Metro Outer Joint Development Assessment Panel Agenda

Meeting Date and Time: Friday, 7 May 2021; 9:30am
Meeting Number: MOJDAP/84
Meeting Venue: City of Rockingham
Civic Boulevard, Rockingham

Development Description: Mixed commercial development
Applicant: Planning Solutions
Owner: Peet Golden Bay
Housing Authority
Responsible Authority: City of Rockingham
DAP File No: DAP/21/01952

**LOT 265 TALISKER BEND, GOLDEN BAY
DEVELOPMENT APPLICATION – PROPOSED MIXED COMMERCIAL DEVELOPMENT
RESPONSE TO REQUESTS FOR FURTHER INFORMATION**

Proposed 7-Eleven, Golden Bay
 Austroads 2013: 19.0m Semi-Trailer
 Fuel Tanker Exit

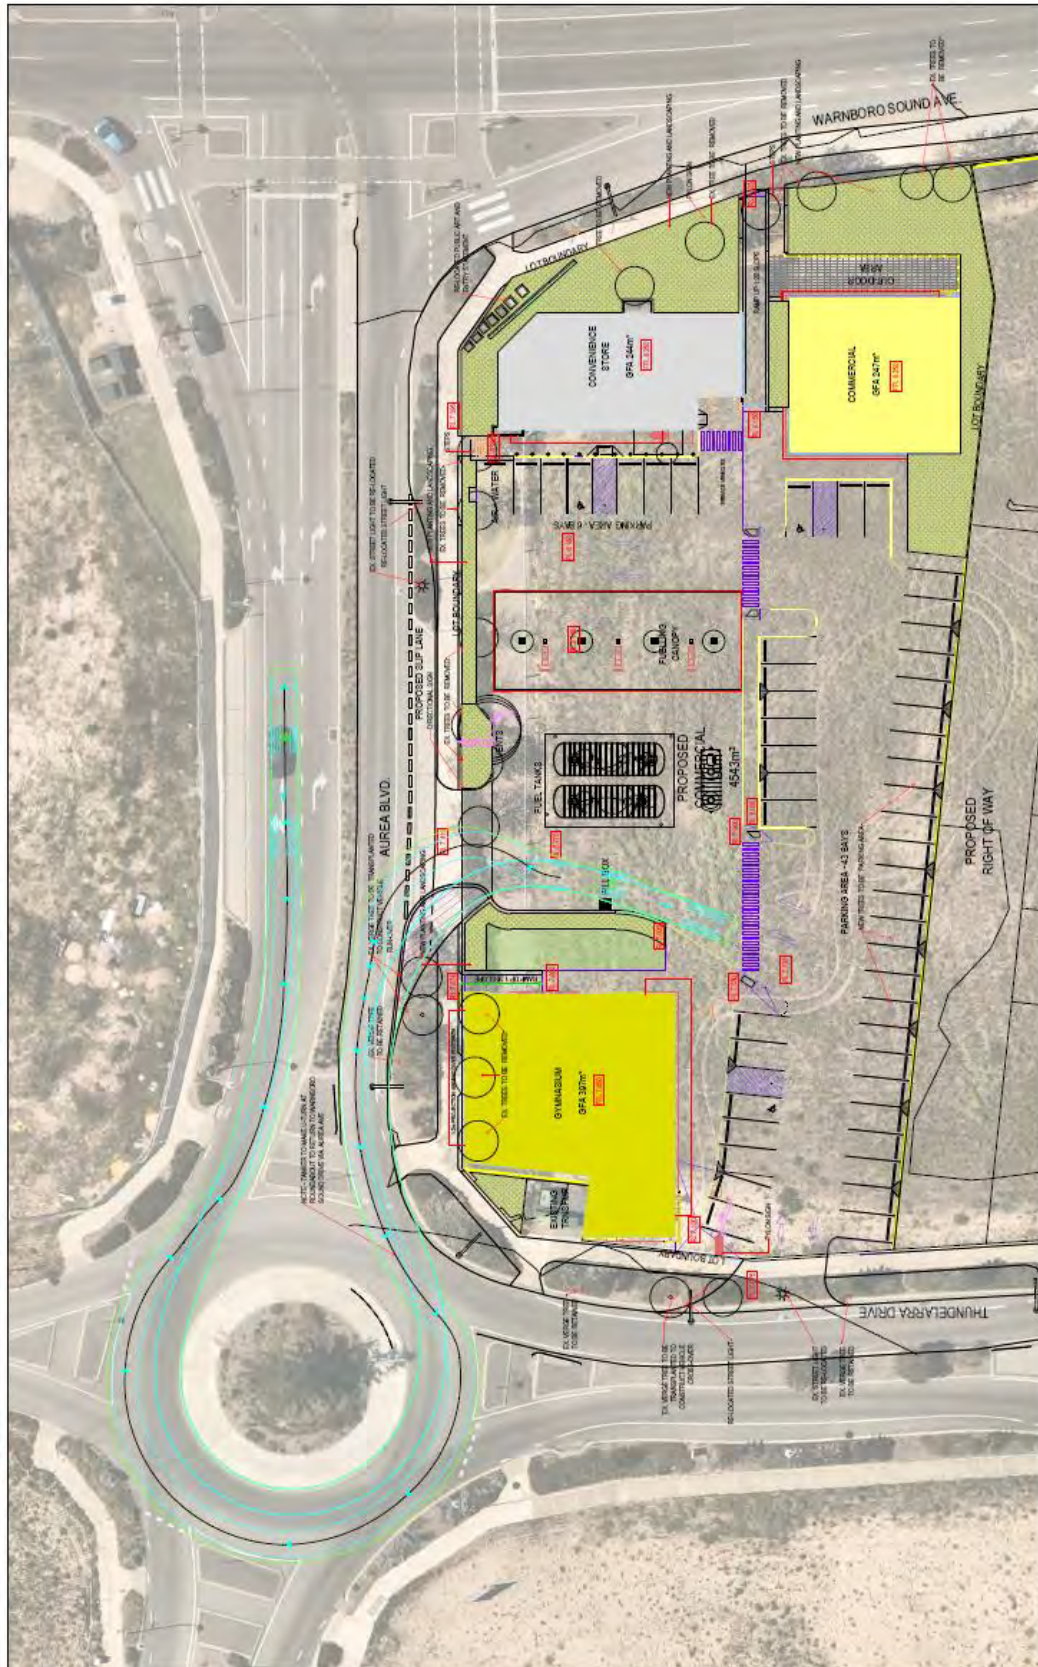
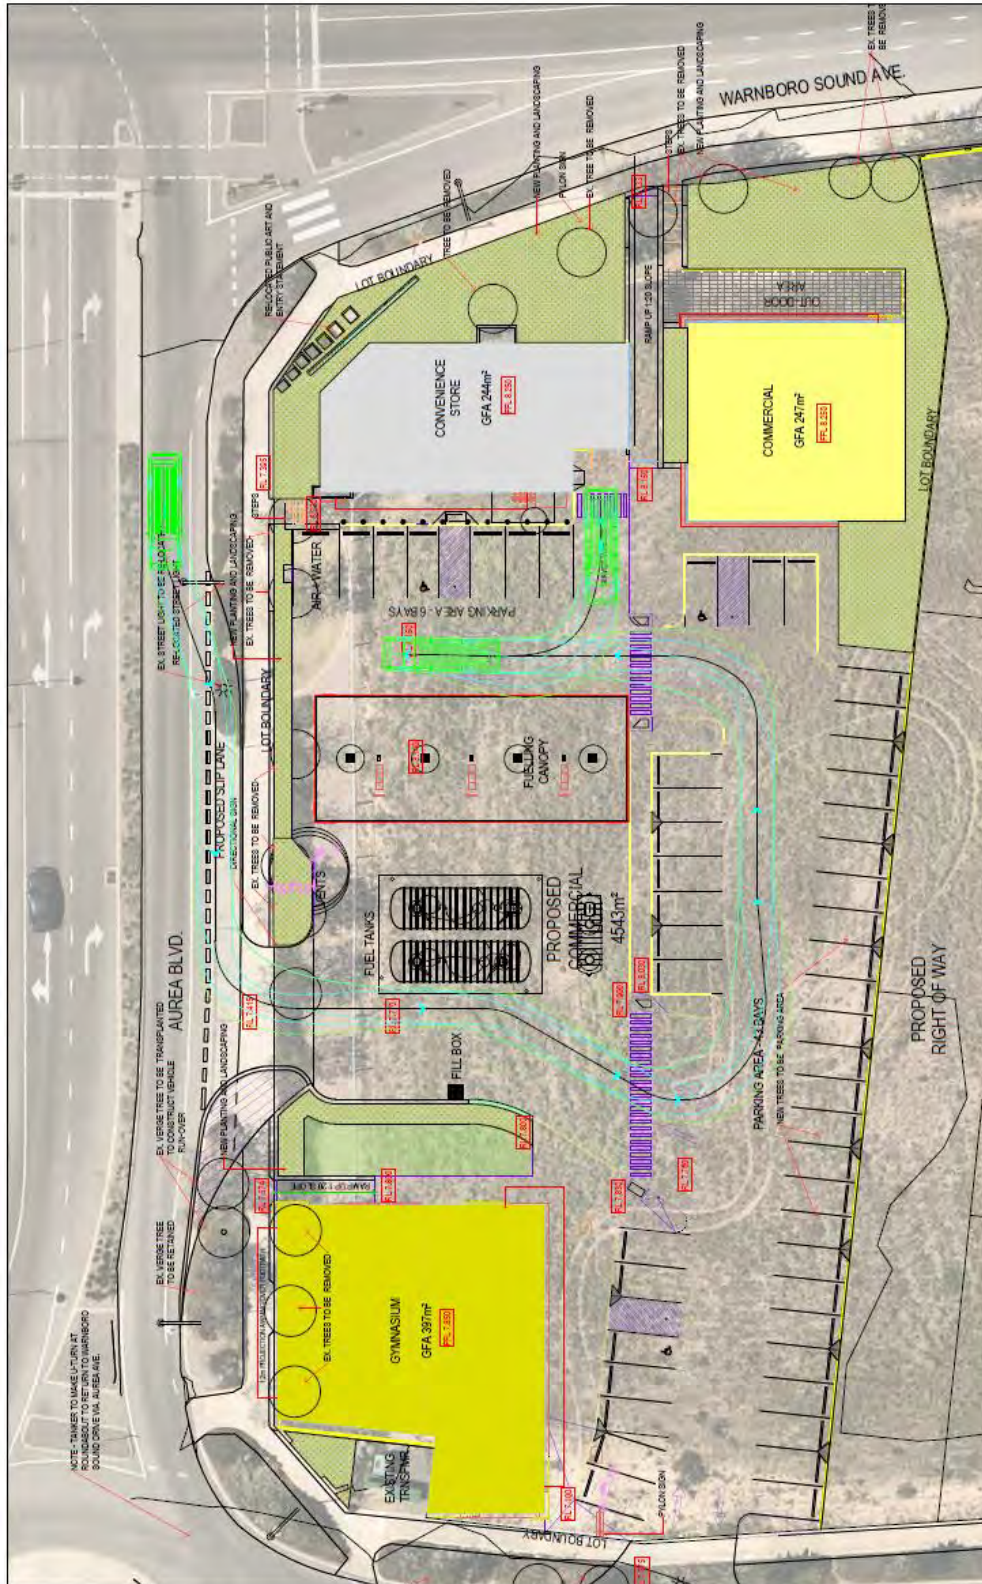
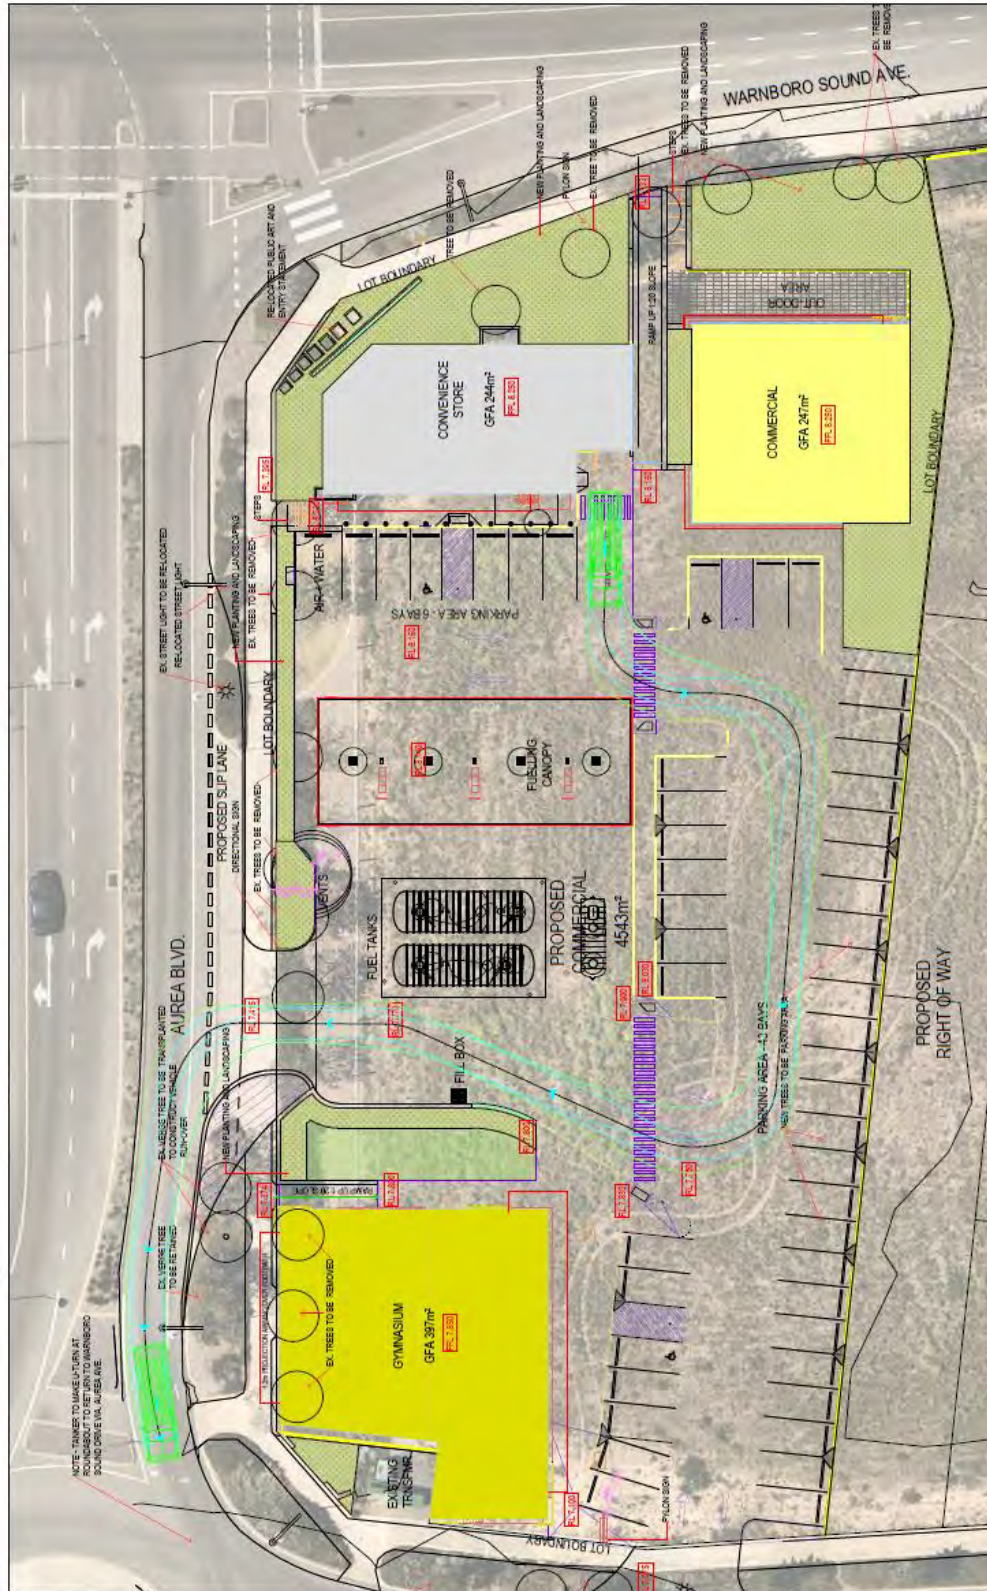
5. The City has concerns regarding the swept path analysis which would increase traffic safety risk.	
Urban Water	
1. The stormwater management plan should be completed and provided to the City prior to determination of the development application. This is due to the current layout indicating no bio-retention treatment will be provided for trafficable areas outside of the service station forecourt, which is a requirement	A Stormwater Management Plan can be provided as an appropriately worded condition of development approval. Biofiltration systems can be incorporated into landscaping area along the lot boundaries at detailed design.

therefore please provide the relevant extract such that its validity could be assessed	
8	<p>The City has concerns regarding the swept path analysis including:</p> <ul style="list-style-type: none"> • Design vehicle encroaching significantly into the opposing traffic lane • Design vehicle encroaching into car parking bays • Clash with kerbing • Reversing movements within the parking aisle <p>Poor resolution for the swept path analysis</p>	<ul style="list-style-type: none"> • The relevant standards and guidelines permit service vehicles to use all available widths of the internal roads of a development when making turns. It should be noted that service vehicles will visit the site infrequently and generally outside the peak operating times. • Please see attached the high-resolution pdf format of the turn paths. As evident the design vehicle does not encroach onto the parking bays. • Please see attached the high-resolution pdf format of the turn paths. As evident the design vehicle does not clash with kerbs. • The design vehicle is permitted to undertake reversing movement over a short distance to access the loading bay. This is normal practice in developments of this nature. It should be noted that service vehicles will visit the site infrequently and generally outside the peak operating times. • The updated turn paths are provided in Appendix B and high resolution plans are provided to City separately.
